PARK PLACE PHASE II SUBDIVISION

MASTER DEVELOPMENT PLAN #748B

Re: Park Place Phase II (Amendment) MDP# 748-B

SHEET 1 OF 1

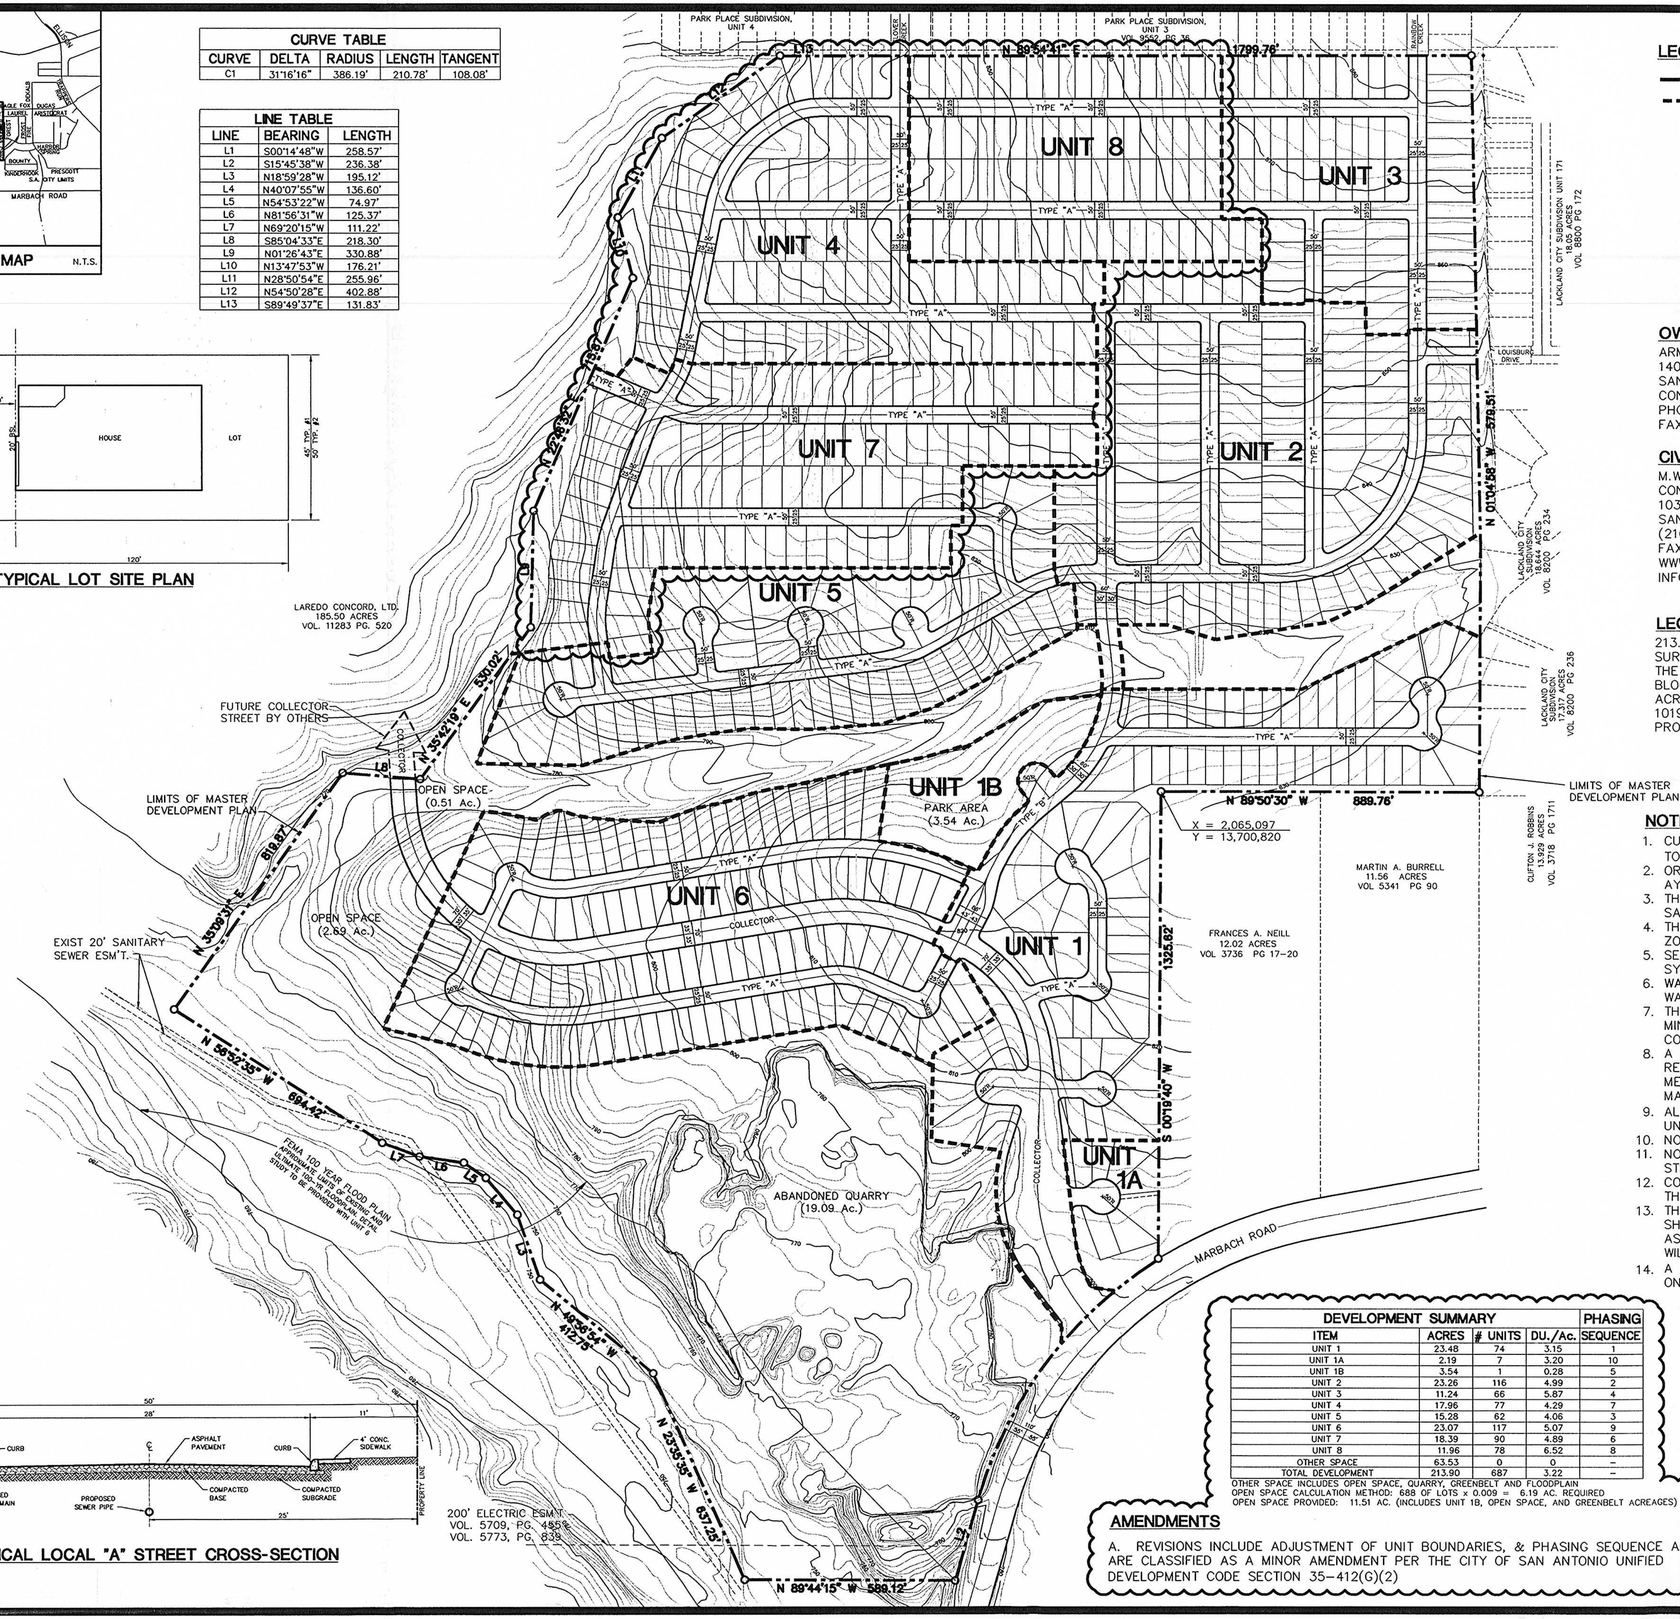
- In consideration of public safety and convenience, excessive grades by reason of topography should be avoided in street layouts and arrangements.

- Development Services, TIA Engineering Section has indicated as part of their conditional approval, improvements along the project limits are necessary and shall be provided by the developer, on and before the completion of the Park Place II Development, at no cost to the City of San Antonio:

1. Construction of an internal collector street (Rousseau Road extension) approximately 3, 140 feet in length. The collector shall consist of 70–feet of ROW and 44-feet of pavement.

2. At the internal collector street (Rousseau Road extension) intersection at Marbach Road, the developer shall design and construct a westbound right-turn lane on Marbach Road (200 feet in length) when this intersection is constructed..

3. At the internal collector street (Rousseau Road extension) intersection at Marbach Road, the developer shall dedicate ROW (200-feet in length) to provide a southbound right-turn lane on the internal collector street (Rousseau Road extension) when this intersection is constructed.

4. The internal collector bridge (all weather crossing) over Medio Creek Tributary, which provides additional access to Park Place II, is required and must be in place prior to completion of the Unit and or Phase adjacent to Medio Creek Tributary.

5. The Local A bridge (all weather crossing) over Medio Creek Tributary shall be designed and constructed under the Phase 5 and or Unit 5. This all weather crossing is a east – west stub out adjacent to the northwest side of the proposed development as shown on the approved Master Development Plan.

6. The additional direct access point from Manor Creek Road (connecting Park Place to Rousseau Road extension) shall be connected once the area west of Park Place and Park Place II is constructed.
